# UNITED STATES PATENT AND TRADEMARK OFFICE

10/779,749

<b>Office Action Summary</b>	<b>Application No.</b> 10/779,749	<b>Applicant(s)</b> KIMURA ET AL.	
	<b>Examiner</b> PHILLIP A. JOHNSTON	<b>Art Unit</b> 2881

***Detailed Action***

**FIG. 3C**

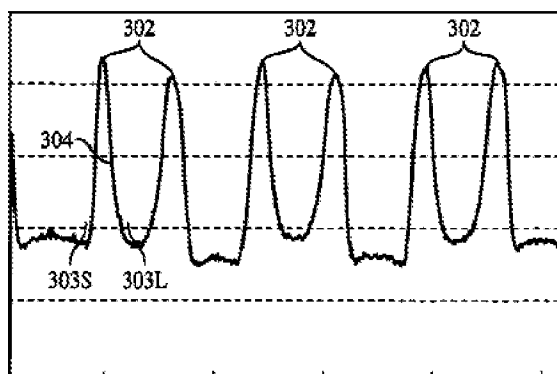
First, it is important to point out that a charged particle scan over a pattern of lines and spaces produces the profile waveform with peaks 302, shown in applicant's Figure 3C below.

Each set of two profile peaks in the waveform define each "line" of the pattern, whereas each "space" in the pattern is defined by the region between the sets of two profile peaks 302. When the first derivative is performed on a set of two profile peaks 302 the resulting derivative waveform includes multiple peaks, at least one positive peak and one negative peak at the point where the rate of change for each of the individual profile peaks is the greatest.

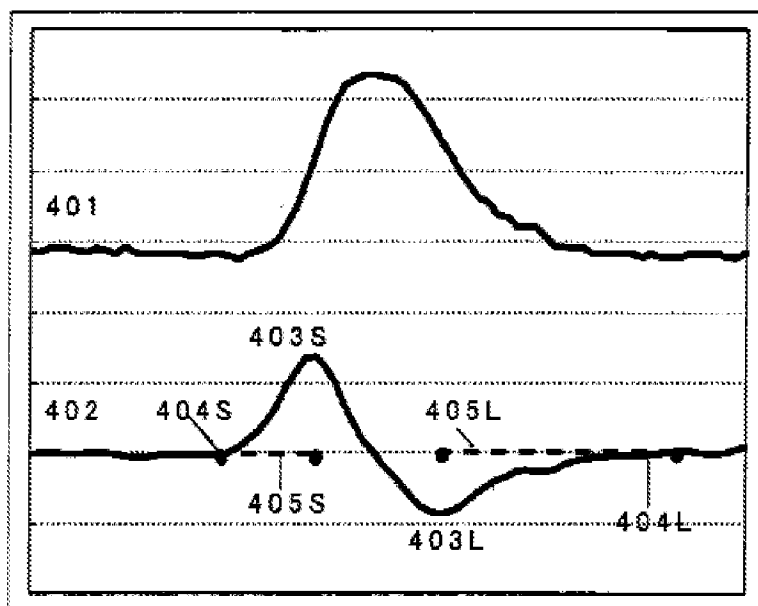
For example at paragraph's [0037] to [0040] a derivative of a single peak 401 is shown below in Figure 4, where the derivative 402 includes one positive peak 403S and one negative peak 403L, and setting distances 405S and 405L to define the space and line portion of one edge of a line pattern respectively.

This section of the applicant's specification would not suggest to one of ordinary skill that, pairs of longer distance values or pairs of shorter distance values are used to define a line or a space.

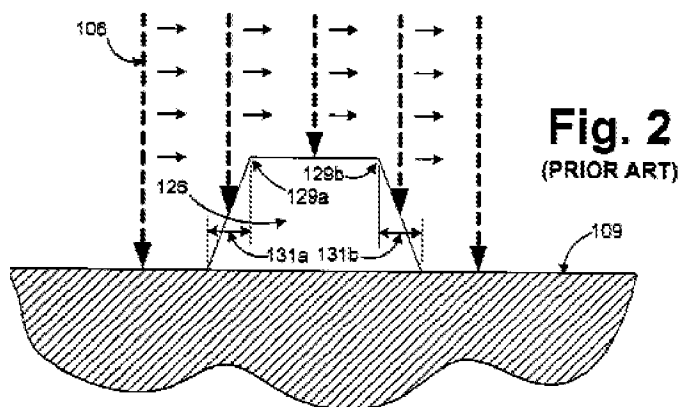
(a) scanning a particle beam scanned over line structure 126 as shown in Figure 2 below. See Col. 2, line 64-66,

**Fig. 3A**

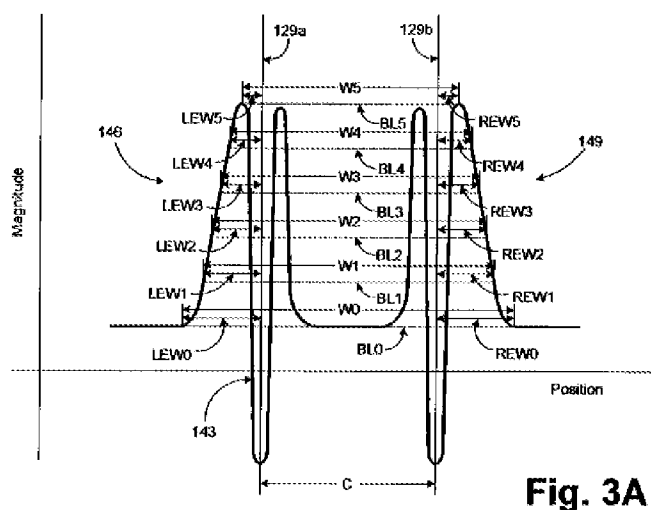
(c) forming the derivative waveform shown in Figure 3A below of the dimensional waveform. Col. 3, line 8-15; and Col. 5, line 5-20,

(d) comparing first longer distances LEW2-LEW5 (Figure 3A below) between the peak and foot of the outer edge of the left positive derivative peak 146 with second shorter distance LEW 5 of the negative derivative peak 143, which defines the transition 131a from the left foot to the top edge of the left profile peak 129a. Col. 3, line 16-50,

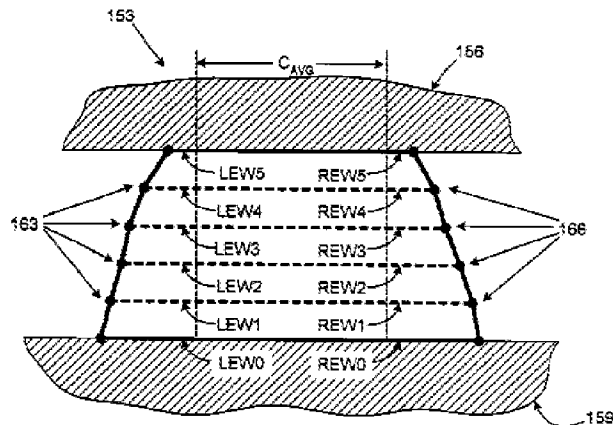
(e) determining the shape of structure 126 from the pairs of longer and shorter distances LEW1-5 and REW 1-5 in the derivative waveform as shown in Figure 3B below. Col. 3, line 63-67 and Col. 4, line 1-30.
